Nebraska Public Power District

October 30, 1980

Subject: Proposed Changes to Technical Specifications
Cooper Nuclear Station
NRC Docket No. 50-298, DPR-46

Figure 3.11-1.3. Maximum Average Planar Linear Heat Generation Rate versus Exposure with LPCI Modification and Bypass Flow Holes Plugged, 8D250 Fuel

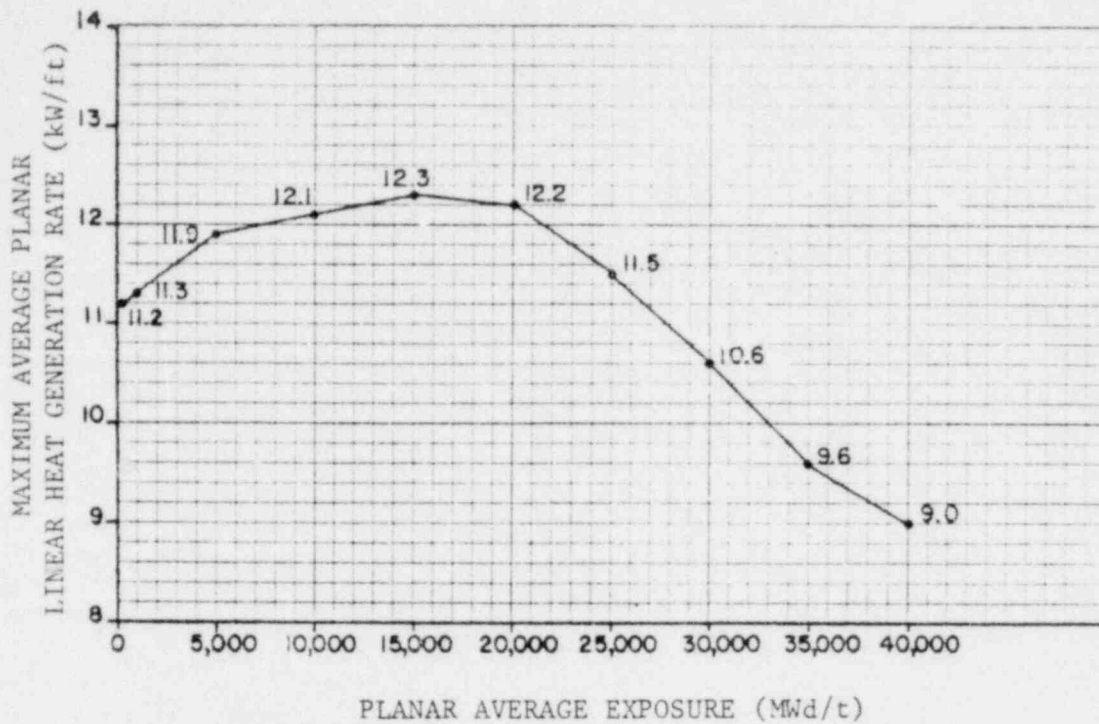
1. Figures 3.11-1.3 and 3.11-1.4, page 211a:

Fuel exposure for Type 8D250 and Type 8D274 fuel at Cooper Nuclear Station is approaching the maximum exposure plotted on the Maximum Average Planar Linear Heat Generation Rate (MAPLHGR) curves. Higher exposure points are being added which were generated using the approved methodology of NEDO-24045 "Loss-of-Coolant Accident Analysis Report for Cooper Nuclear Station." NEDO-24045 was submitted September 1, 1977, and was utilized in Amendment 39 to the Facility Operating License.
